**EL PASO WATER UTILITIES
PUBLIC SERVICE BOARD**

ADDENDUM NO. 2

**JOHN T. HICKERSON WRF
HEADWORKS BARSCREEN REPLACEMENT**

BID NO. 40-23

C GRIT PUMP DEMOLITION PLAN
SCALE: 1/4"=1'-0"

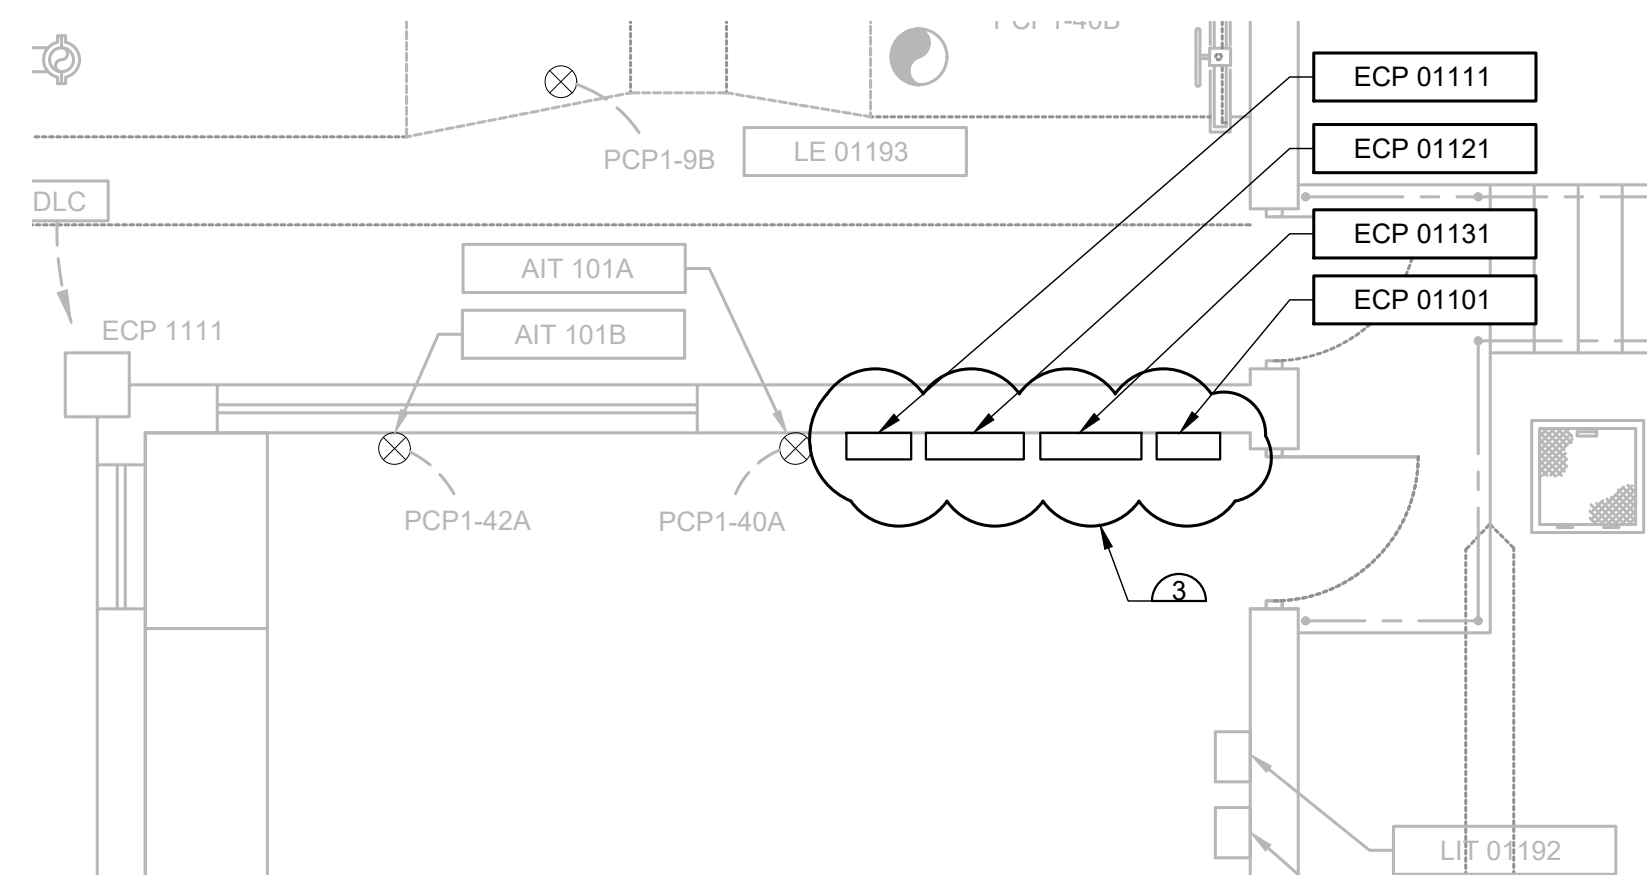
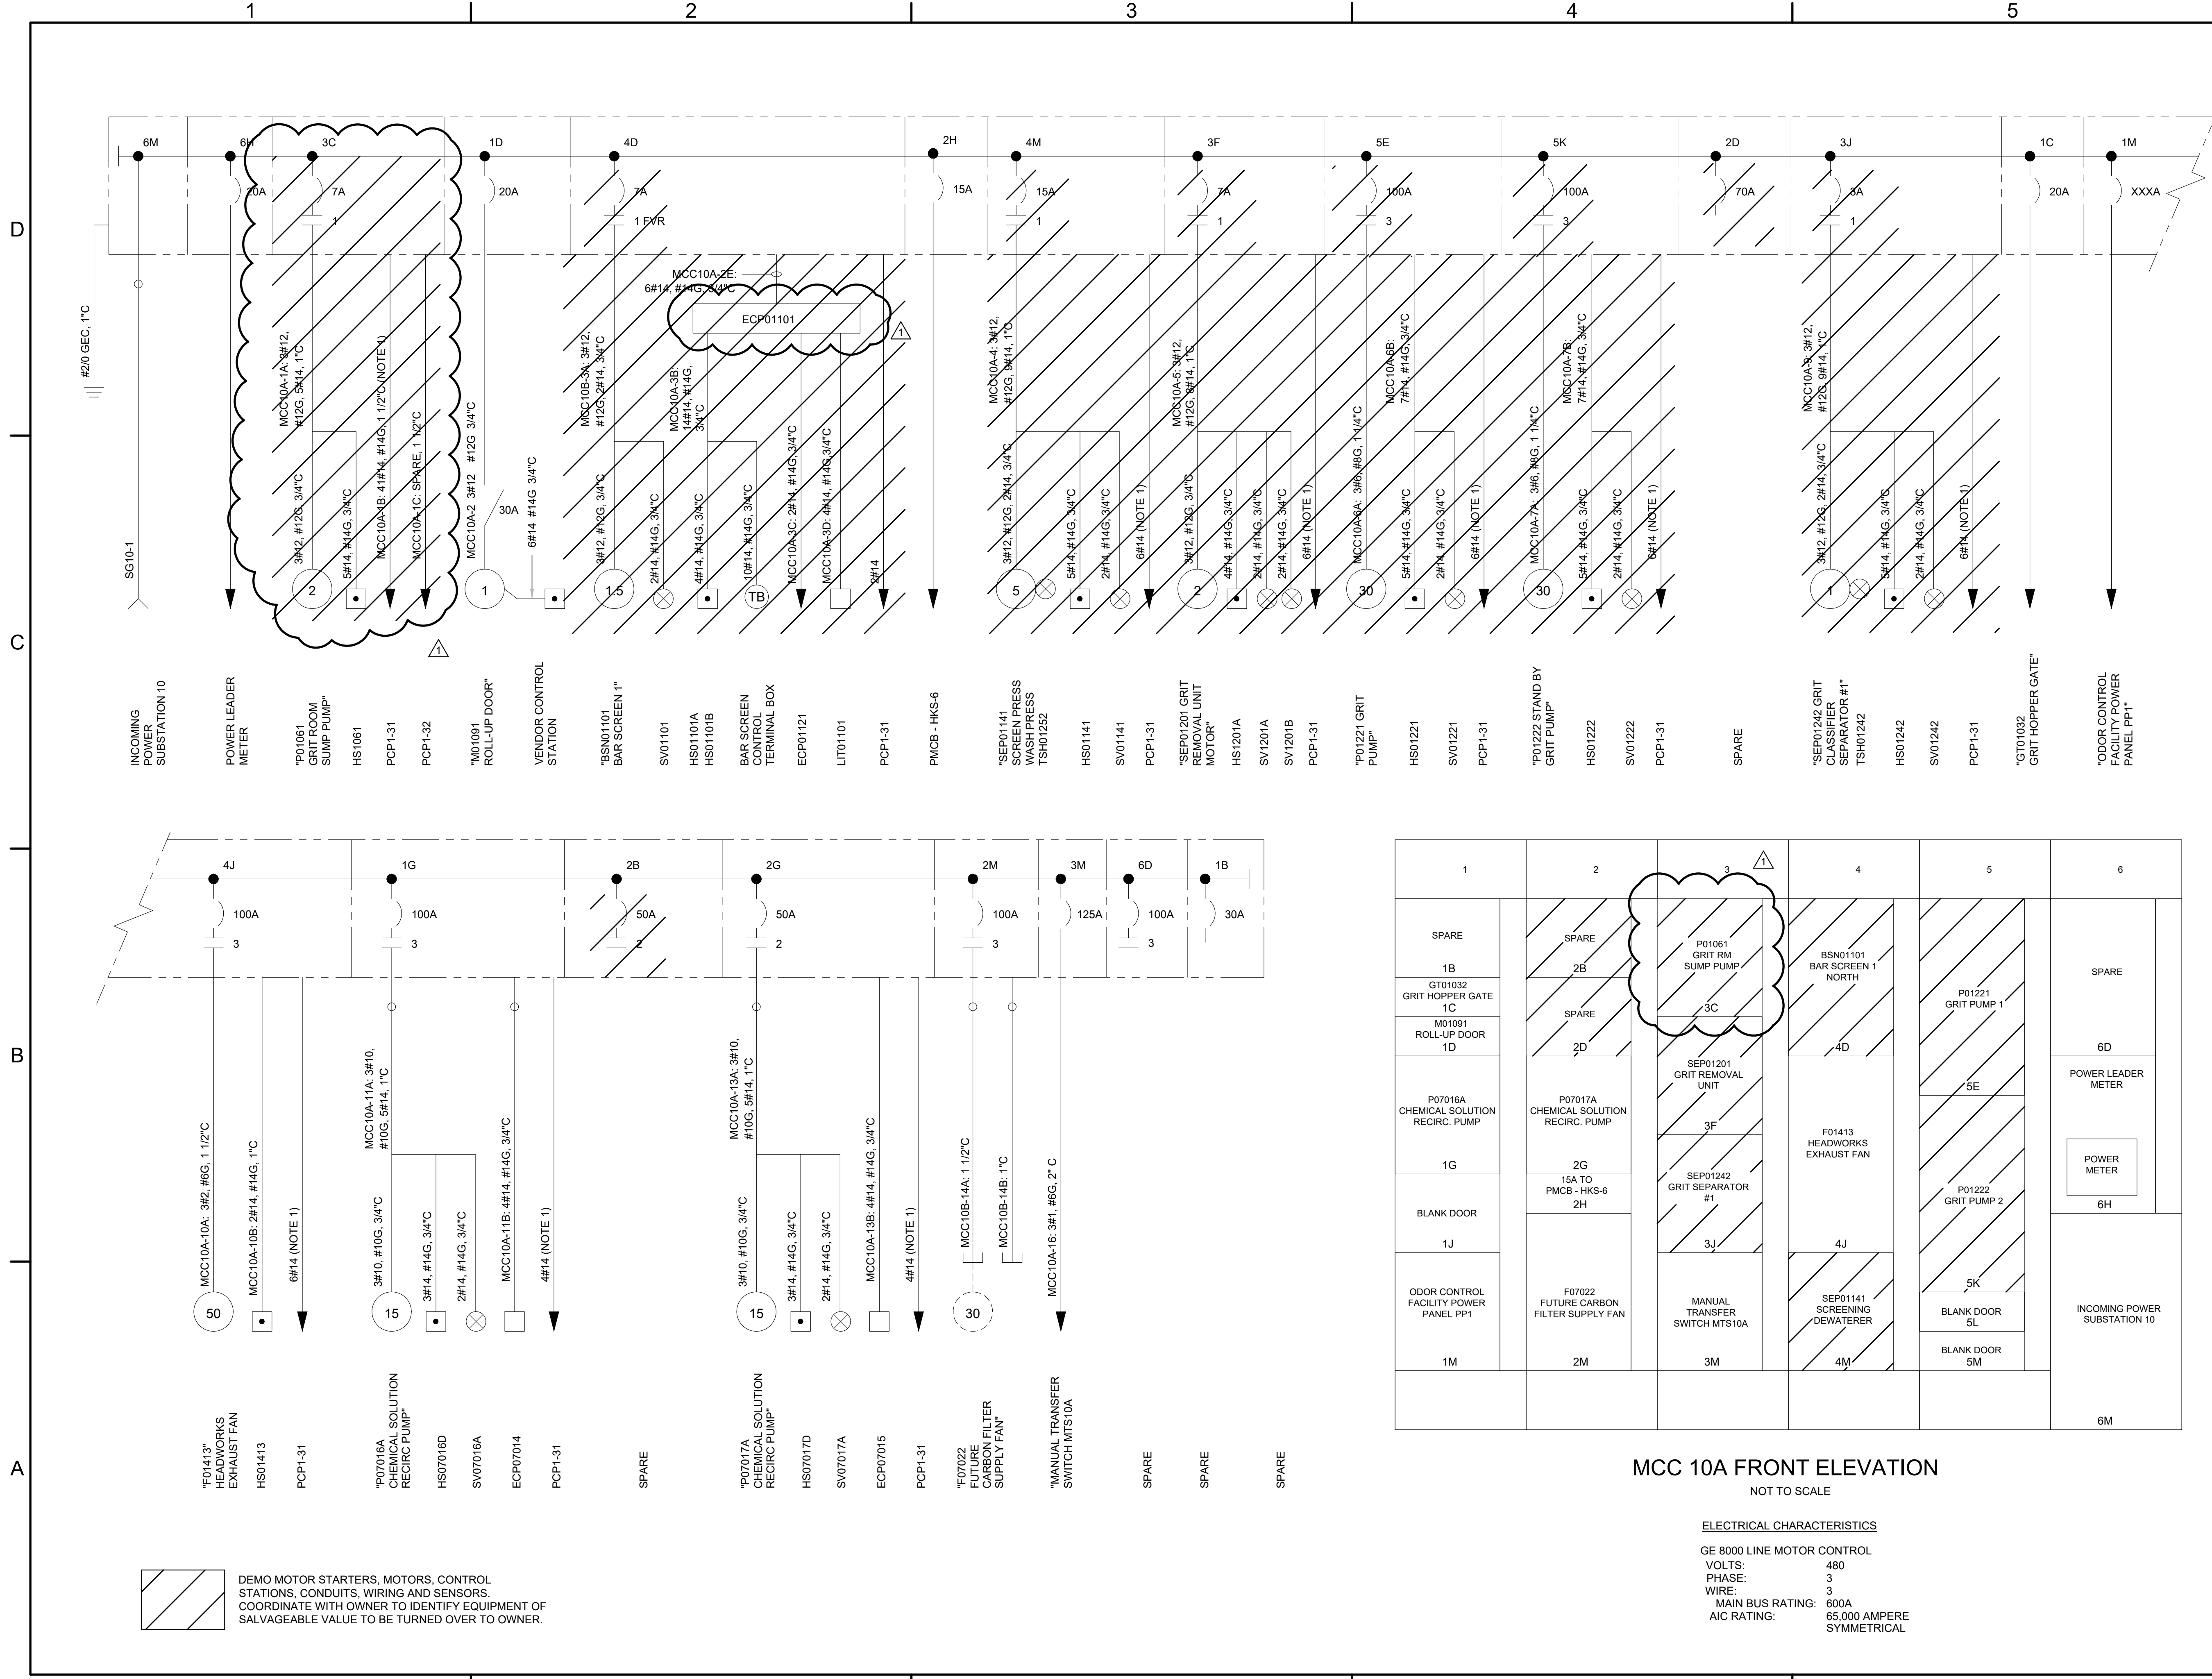
- AD-2.26. SHEET E004 – ELECTRICAL DEMOLITION PLAN
- A. REMOVE Sheet E004 in its entirety and REPLACE with revised Sheet E004 attached to this Addendum. Changes reflect demolition of Grit Room sump pumps.

Q-2.04. Sheet M106, Plan E – Grit Pumping Room Partial plan indicates the existing sump pumps are to be removed and replaced. Sheet E004, Plan C – Grit Pump Demo Plan does not show demolition of the sump pumps. Sheet E009 does not show electrical work being required for the sump pumps. Is electrical work required?

A-2.04 Electrical work will be required. See Addendum Drawings for electrical demo and replacement work related to replacement of Grit Pumping Room sump pumps.

**ELECTRICAL
MCC-10A
ONE-LINE DIAGRAM
DEMO-SHEET**

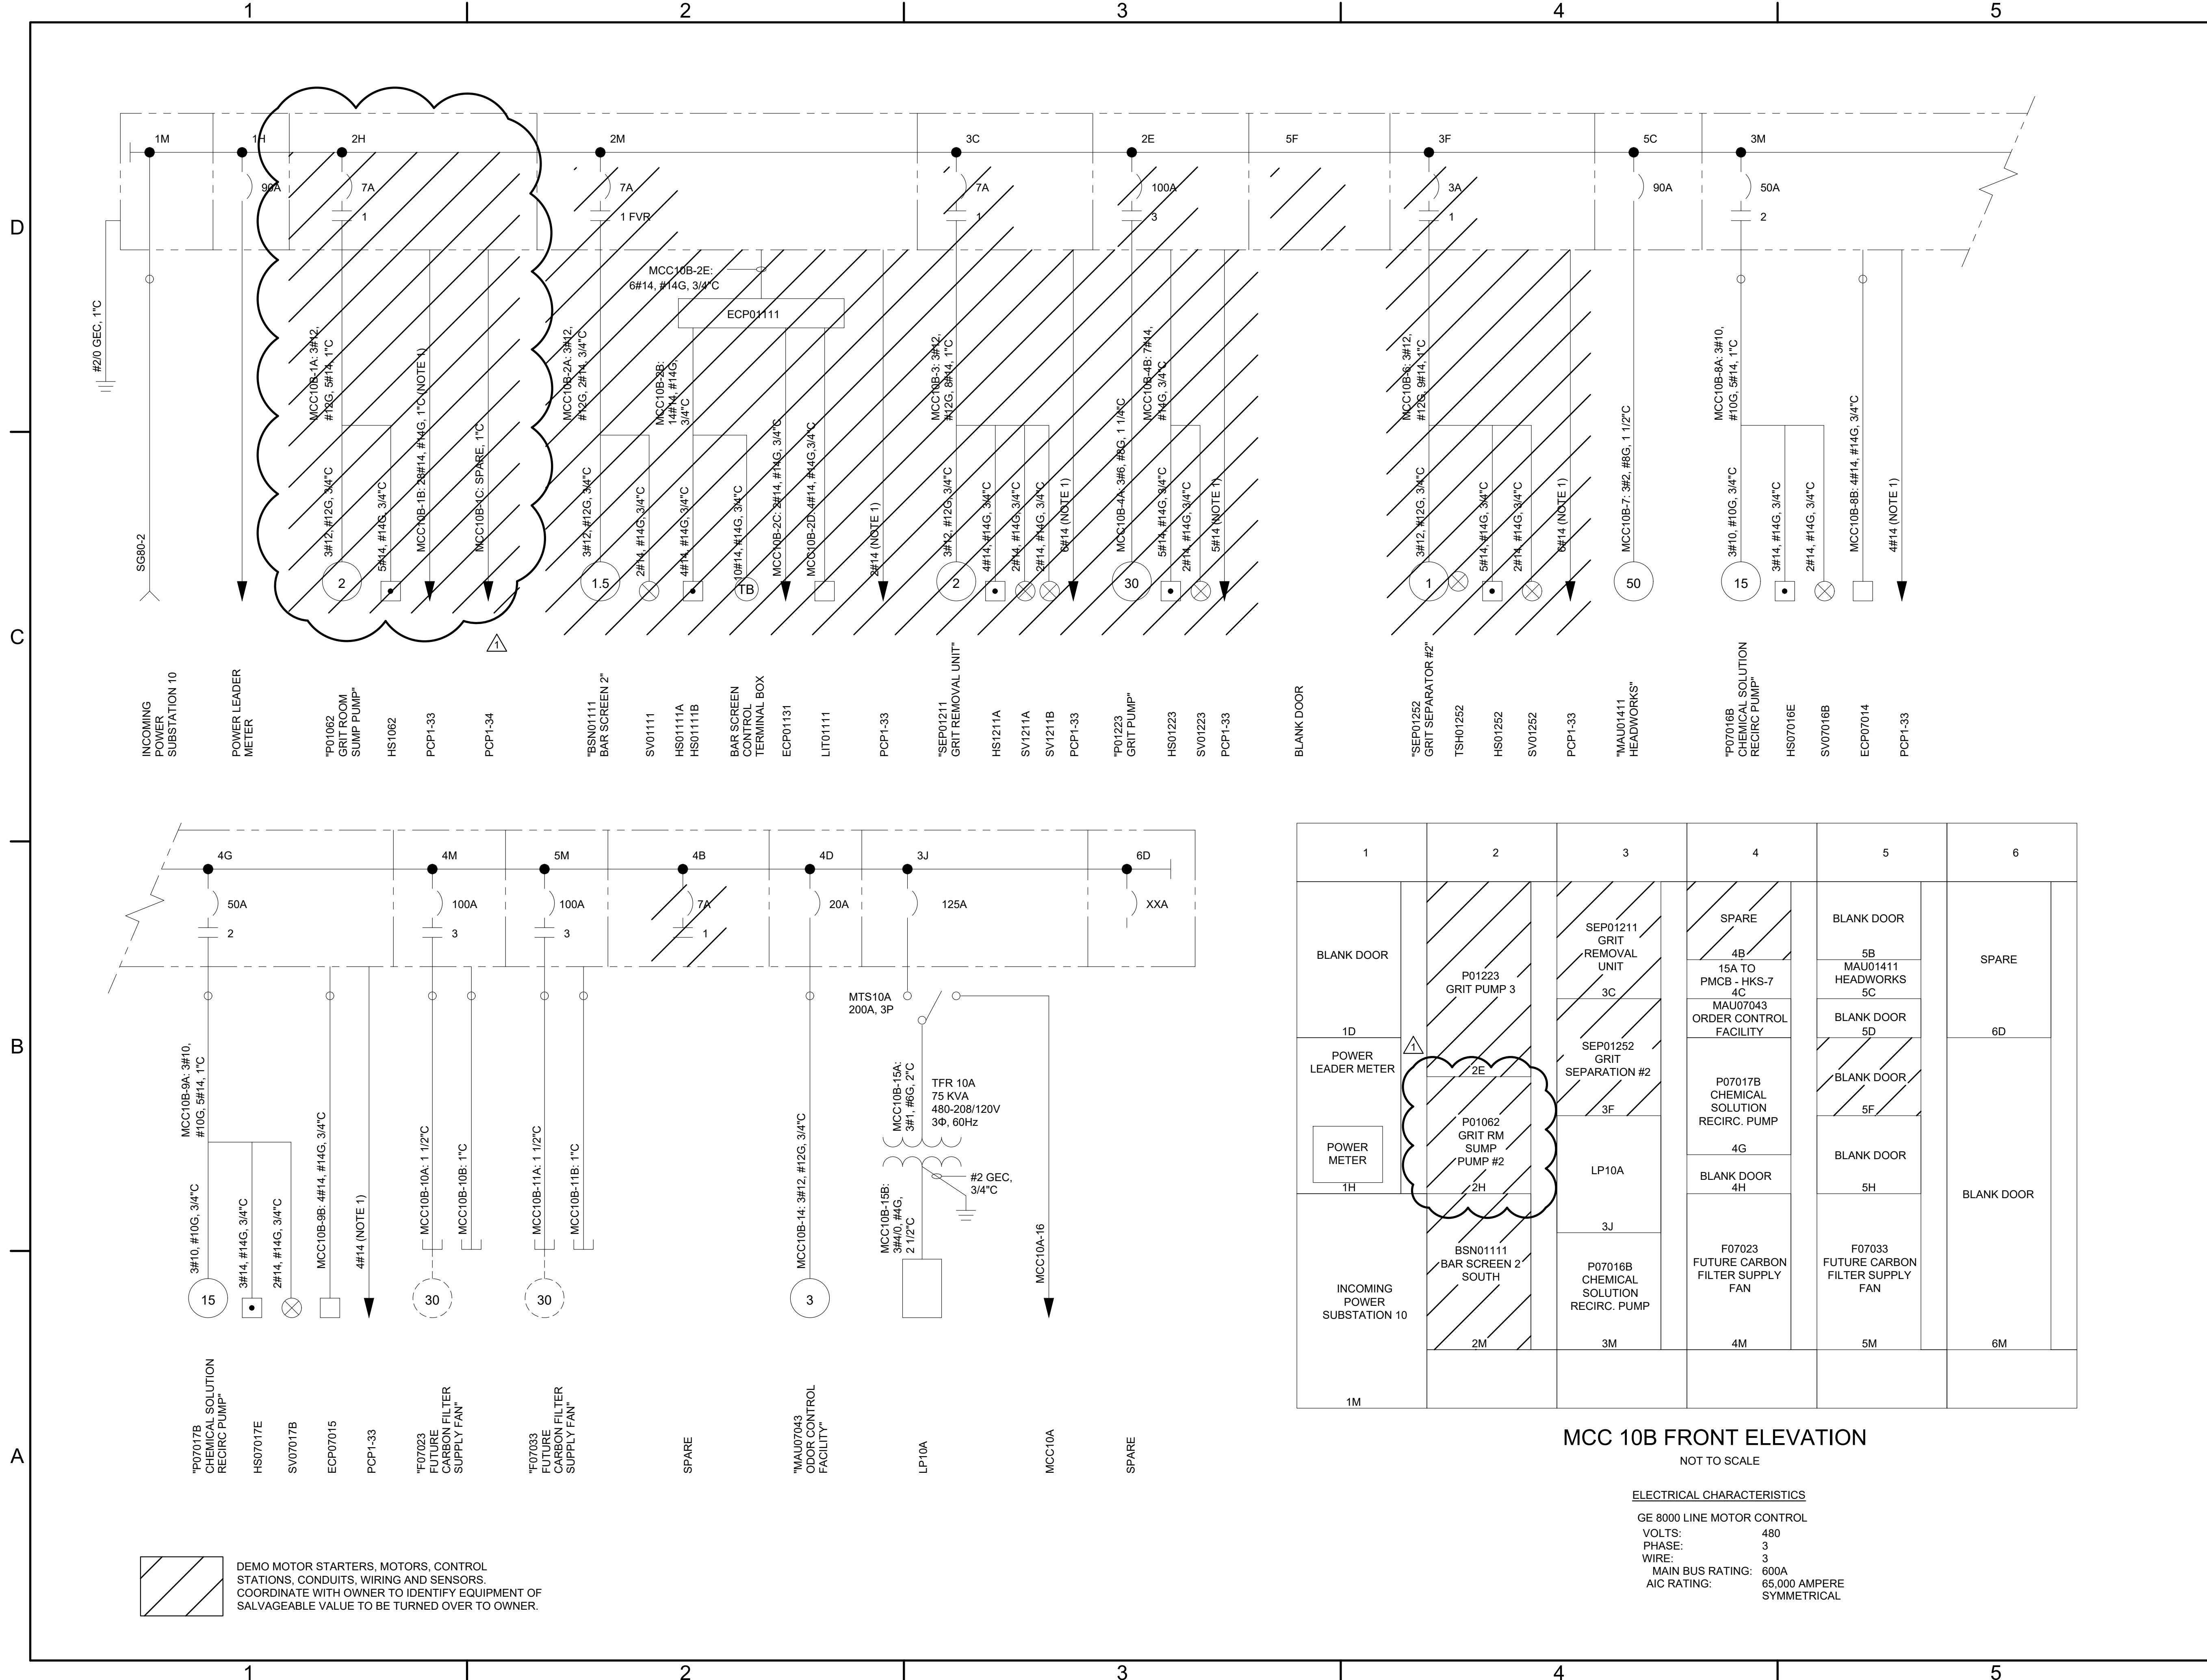
- AD-2.27. SHEET E005 - ELECTRICAL MCC-10A ONE-LINE DIAGRAM DEMO-SHEET
- A. REMOVE Sheet E005 in its entirety and REPLACE with revised Sheet E005 attached to this Addendum. Changes reflect demolition of Grit Room sump pump.
